List of Changed Pages

### 3.0 INSERVICE TESTING OF VALVES

Table V-1 Valve Test Program

TO REVISE DWG D-175034 AS SHOWN:

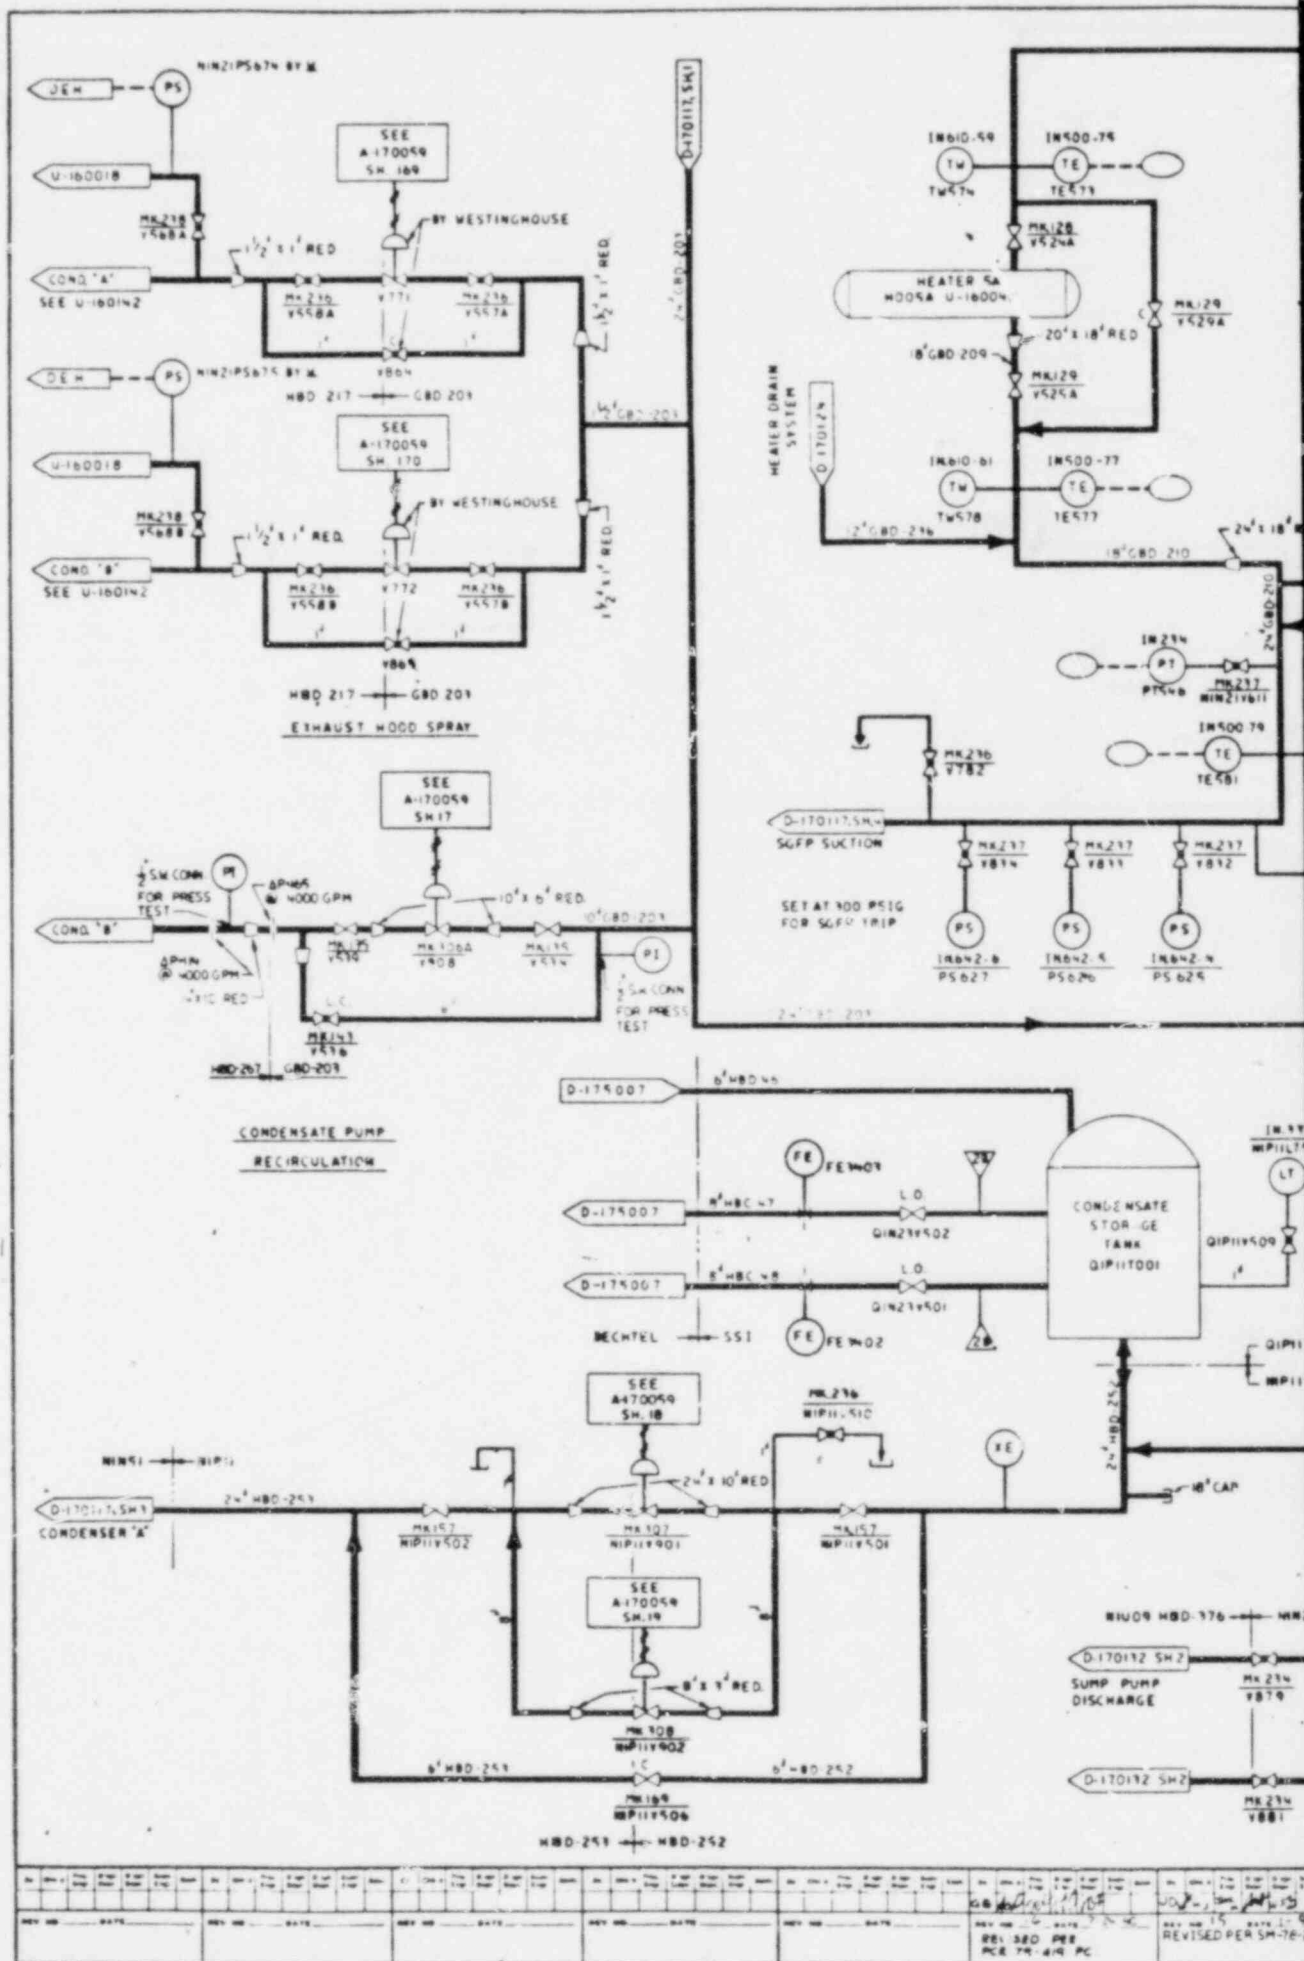
(1) These valves are not yet shown on a P&ID. A temporary sketch is provided on page 3-103. The P&ID's will be revised to reflect these changes on a later date.
